Office Action Summary

09/705,996

ZHAO ET AL.

DETAILED ACTION

Fig. 16

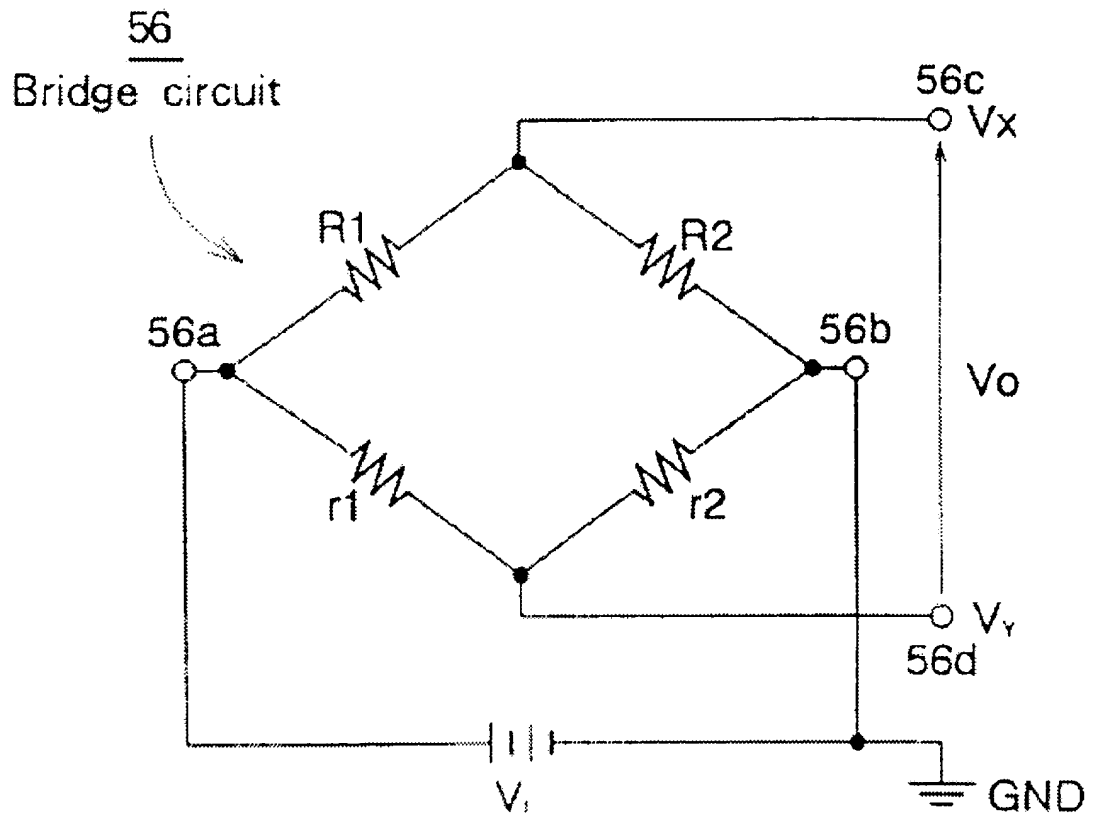
Referring to claim 11, Hosoi teaches the chip above, wherein each temperature sensing element has a respective first terminal and a respective second terminal, wherein the respective second terminals of the temperature sensing elements are connected, wherein the acceleration sensor is operative to generate the differential output voltage across the respective first terminals of the temperature sensing elements (Figs. 5 and 16), and wherein the acceleration sensor is further operative to set the connected respective second terminals of the temperature sensing elements to a desired voltage level proportional to the reference voltage level (See Figs. 5 or 16, elements 56a and 56b).

FIG. 11

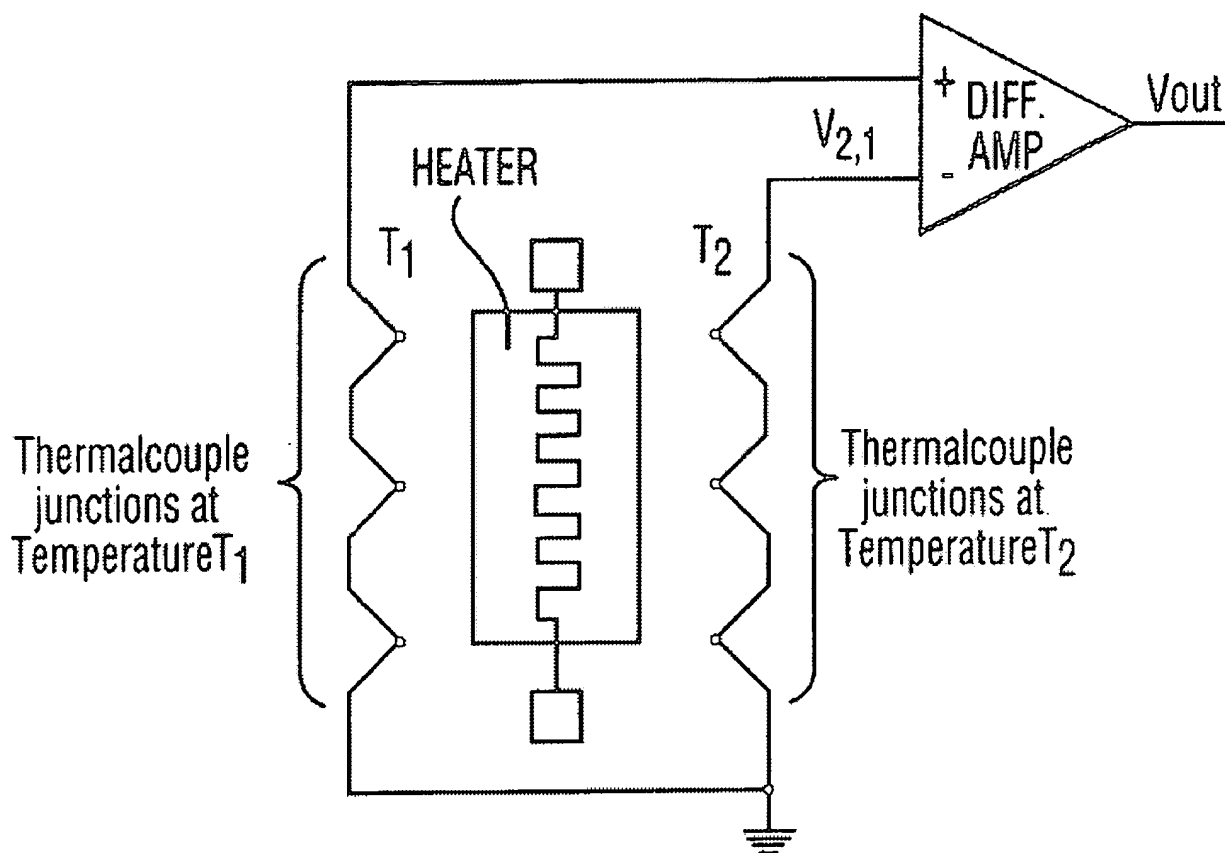
a convective acceleration sensor including a heater element and a plurality of temperature sensing elements (Abstract; Fig. 11), the plurality of temperature sensing elements being operative to generate a differential output voltage indicative of a magnitude of acceleration applied along at least one axis passing through the heater element and the plurality of temperature sensing elements (Col. 2, lines 29-30; Col. 9, claims 9 and 16; Col. 5, lines 13-27); Leung clearly teaches amplification circuitry configured to receive the differential output voltage generated by the plurality of temperature sensing elements (See Fig. 11 below).
